Great Yarmouth Third River Crossing Order 202[*]

Document NCC/GY3RC/EX/077: Response to Request for Further Information (Rule 17)

Document Reference: NCC/GY3RC/EX/077

MEMO

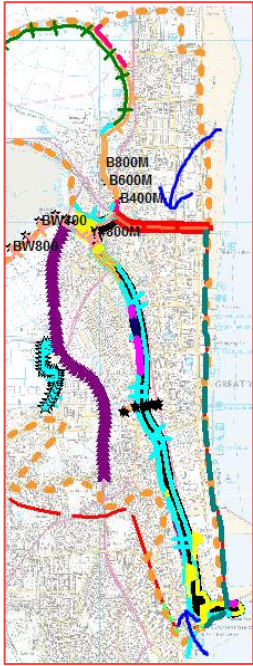
Environment Agency (EA)			Norfolk County Council
Item Checked	EA Comments	Action Suggested by EA	WSP Response
	<i>JBA 2018 have included culvert data that should also be in the model. This data appears to be located in the .ecf files of the appropriate models.</i>	<i>Include subways & culverts in model. Also apply local adjustment to new LIDAR files to allow access passage to these structures, consistent with Halcrow 2011.</i>	Actioned. Within the further sensitivity modelling the subways and culverts have been included.
<i>Are defences/ embankments/ bank crests accurately represented?</i>	<i>The crest levels (i.e. 3m) of JBA 2018 file 2d_zln_Great_Yarmouth_defences_Breydon_Water doesn't seem to be incorporated into the relevant 1D cross sections.</i>	<i>Correct and include in future model work.</i>	Actioned. Within the further sensitivity modelling the Breydon Water has been included in the 2D domain. The crest levels (2d_zln_Great_Yarmouth_Breydon_Water) has been included as a zline with constant value of 3m AOD.
